Access Compliance Report

Public Rights-of-Way

(Curb Ramps)

Intersection ID: 53147	Main Street: ACHIEVEMENT_LN	Cross Street: NEW_RENAISSANCE_WY	Location: NE
ADA ID: E571B5F0282B	Ramp Type: Perp	Initial Pass/Fail: Fail	Overall Compliance: No
Severity Score: 13.75			
Codes/Mitigation Info/Possible Solution		Field Measurements/Component Compliance

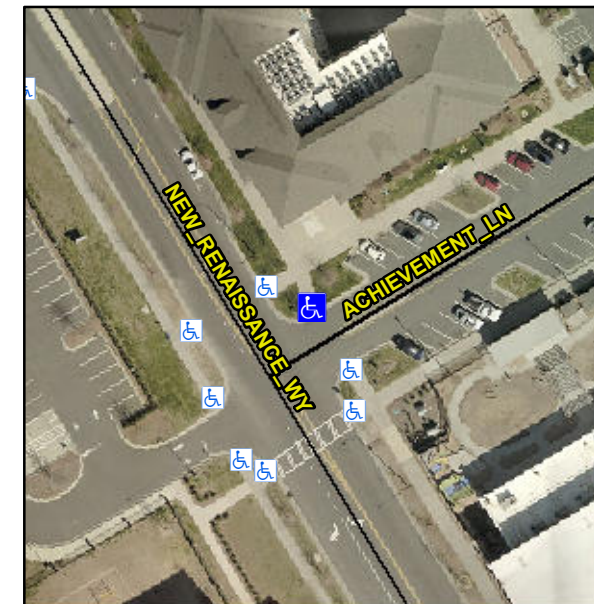
R304.2.2, R304.5.3

Compliance	Description	Data	Compliance	Description	Data
N/A	Ramp Length (in)	78.0	No	Ramp Slope (%)	8.5
Yes	Ramp Width (in)	96.0	No	Ramp XSlope (%)	4.5
N/A	Flare Type LT	N/A	N/A	Flare Type RT	N/A
N/A	Flare Slope LT (%)	N/A	N/A	Flare Slope RT (%)	N/A
N/A	Flare Traversable LT?	N/A	N/A	Flare Traversable RT?	N/A
N/A	Landing Length (in)	N/A	N/A	DWS Provided?	N/A
N/A	Landing Width (in)	N/A	N/A	DWS Contrast?	N/A
N/A	Landing Slope (%)	N/A	N/A	DWS Length (in)	N/A
N/A	Landing X Slope (%)	N/A	N/A	DWS Full Width?	N/A
N/A	Landing Curb? (Y/N)	N/A	N/A	DWS Offset (in)	N/A
N/A	Shared Landing?	N/A			
N/A	Gutter Ponding?	N/A	N/A	Gutter Slope (%)	N/A
N/A	Gutter Lip Ht (in)	N/A	N/A	Gutter X Slope (%)	N/A
N/A	Painted X Walk1?	No	N/A	Painted X Walk2?	N/A
	X Walk 1 Direction	To SE		X Walk 2 Direction	N/A
N/A	X Walk 1 Width (in)	N/A	N/A	X Walk 2 Width (in)	N/A
	X Walk 1 Slope (%)	2.3		X Walk 2 Slope (%)	N/A
	X Walk 1 X Slope (%)	3.3		X Walk 2 X Slope (%)	N/A

Remove & Replace Entire Ramp.
